SERVICE LETTER 210

10000A Water Scoop Harness Upgrade

This service letter applies to Air Tractor model AT-802 and AT-802A with Wipline 10000 Floats installed per STC SA01795CH.

This is a repair option for watertight position switches for the scoop actuators. This Service Letter provides instruction to upgrade from Service Letter 191.

Work Instructions For Kit 1011438-01

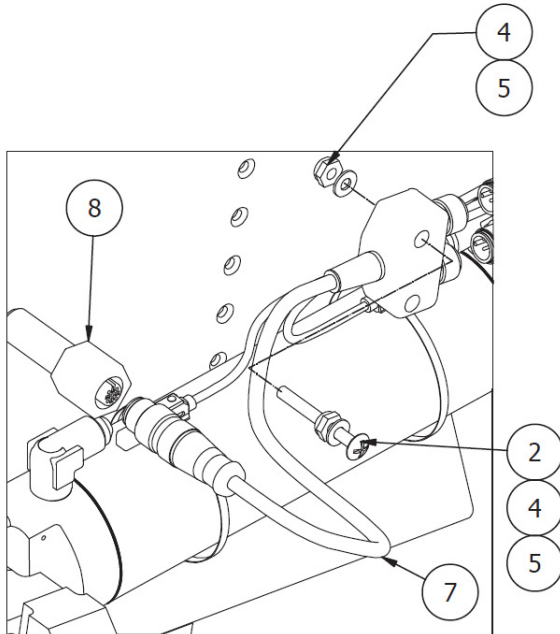
The purpose of this installation is to retrofit Wipaire, Inc. OEM Water Scoop Position Sensor Systems with improved watertight position switches for the scoop actuators. Quantities shown in parts list is for two floats.

4. Install 1 Washer (NAS1149D0863J) to Connector, 4 Pin Feed-Thru (U1135-1) as shown. Insert 4 Pin Feed-Thru through mount hole from the tunnel side outwards. Install 1 Washer (NAS1149D0863J) and 1 Lock-Washer (LW-M12) to Connector, 4 Pin Feed-Thru and secure with Locknut (LN-M12). Use Sika-Flex, proseal or equivalent to seal junction through tunnel wall.

5. Connect Fire Boss Scoop Harness Adapter (1011437) to existing float harness and to Connector, 4 Pin Feed-Thru. Ensure connector ends and internal area remain free of sealant. S-fold and secure the excess wiring to the adjacent hydraulic lines with plastic cable-ties.

6. Before installation, remove screws from Inductive Magnet Sensors (1011941-01). Mount switches on each scoop hydraulic actuator using the ASB-6 Straps (M6965106) and Cord Sets (S693351).

SPLITTER STOWING DETAILS

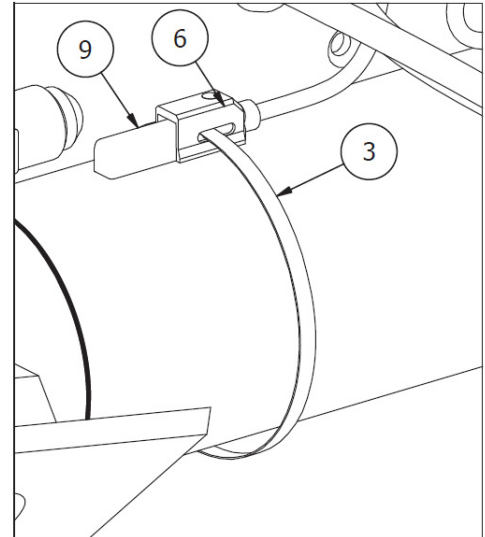
8. Re-install hydraulic actuator assembly with previously removed hardware.
 9. Install 1 Screw (AN526-832R12) with Proseal, or equivalent, (facing inwards) in previously drilled hole with 1 Washer (NAS1149FN832P) and 1 Nut (MS21083N08). Mount Splitter to this screw. Secure splitter with 1 Washer (NAS1149FN832P) and Nut (MS21083N08). Do not over-tighten. S-fold and secure the excess wiring with plastic cable-ties.

Work Instructions For Kit 1011438-02

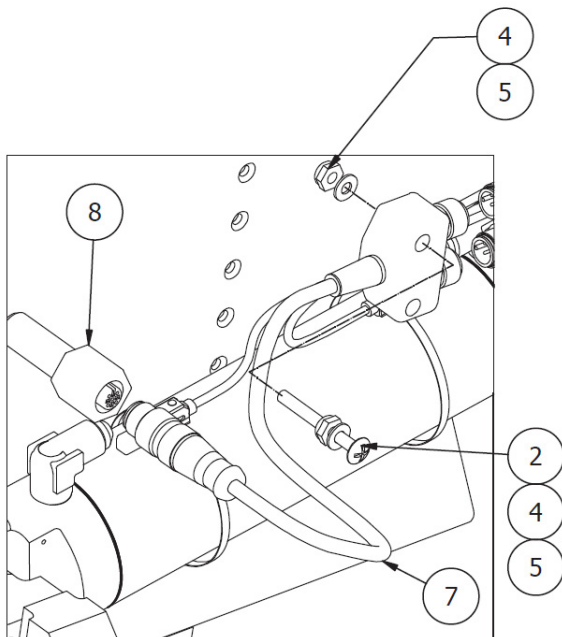
The purpose of this installation is to add an upgrade to the system previously modified in accordance with Wipaire Service Letter 191. This upgrade adds higher performance watertight harnesses and fittings to reduce effects of salt-water corrosion on the harness interface area on the scoop tunnel.

2. Disconnect existing plugs from scoop tunnel side wall.
3. Install 1 Washer (NAS1149D0863J) to Connector, 4 Pin Feed-Thru (U1135-1) as shown. Insert 4 Pin Feed-Thru through mount hole from the tunnel side outwards. Install 1 Washer (NAS1149D0863J) and 1 Lock-Washer (LW-M12) to Connector, 4 Pin Feed-Thru and secure with LockNut (LN-M12). Use Sika-Flex, ProSeal or Equivalent to seal junction through tunnel wall.

4. Connect Fire Boss Scoop Harness Adapter (1011437) to existing float harness and to Connector, 4 Pin Feed-Thru. Ensure connector ends and internal area remain free of sealant. S-fold and secure the excess wiring to the adjacent hydraulic lines with plastic cable-ties.

SPLITTER STOWING DETAILS

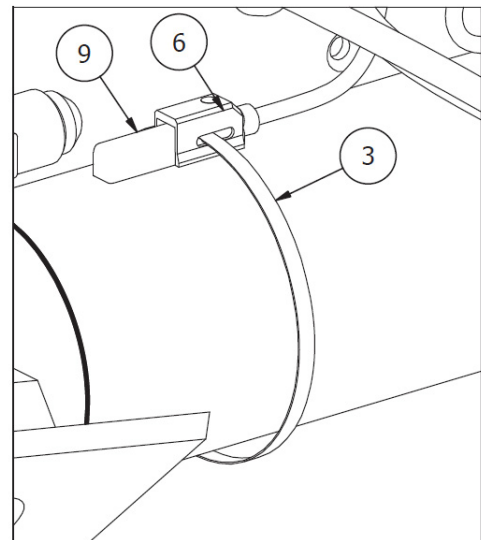
7. Install 1 Screw (AN526-832R12) with ProSeal, or equivalent, (facing inwards) in previously drilled hole with 1 Washer (NAS1149FN832P) and 1 Nut (MS21083N08). Mount splitter to this screw. Secure splitter with 1 Washer (NAS1149FN832P) and Nut (MS21083N08). Do not over-tighten. S-fold and secure the excess wiring with plastic cable-ties.
